Our ref: HGY/2023/1601 Contact: Zara Seelig Date: 15/08/2024
Town and Country Act 1990 (As amended)		
Location:	Imperial House, 64 Willoughby Lane, Tottenham, London, N17 0SP	
Proposal:	Upward extension to allow for additional office space

Carbon Management Response 07/06/2023

Carbon Management Response 15/08/2024

Roof plan showing solar panels:

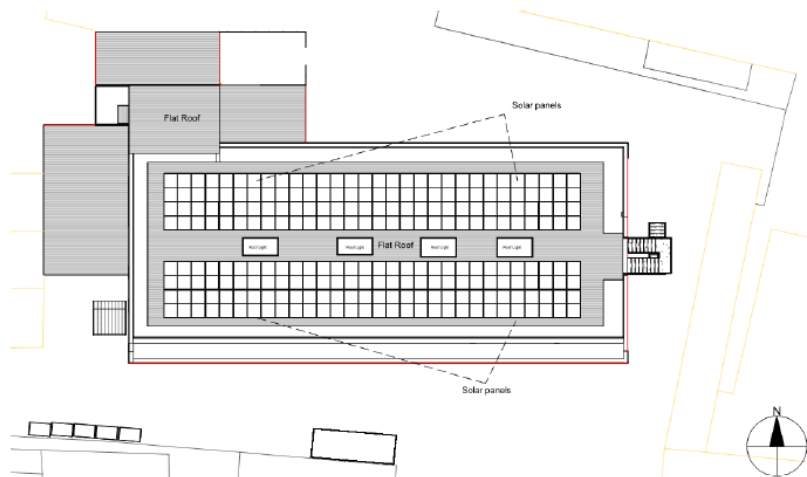
- Please provide some commentary on how the available roof space has been maximised to install solar PV. Has your feasibility shown that other roofs will not be viable / will they be used for other purposes?
- Please annotate the proposed Solar PV on the roof plans.
- A living roof should be installed under the solar PV, or if this is not feasible, the roof should be light coloured to reduce solar heat gains and to improve efficiency of the solar panels.
- Please identify on the plans where the internal and external parts of the air source heat pumps will be located and how the units will be mitigated in terms of visual and noise impact.
- Please provide the detailed specifications of the proposed ASHP.
- How much of the heating/hot water demand will be met by the proposed type of heat pump? If this cannot be met fully, how will this be supplemented?

The revised proposed solar PV will have a peak output 40 kWp.
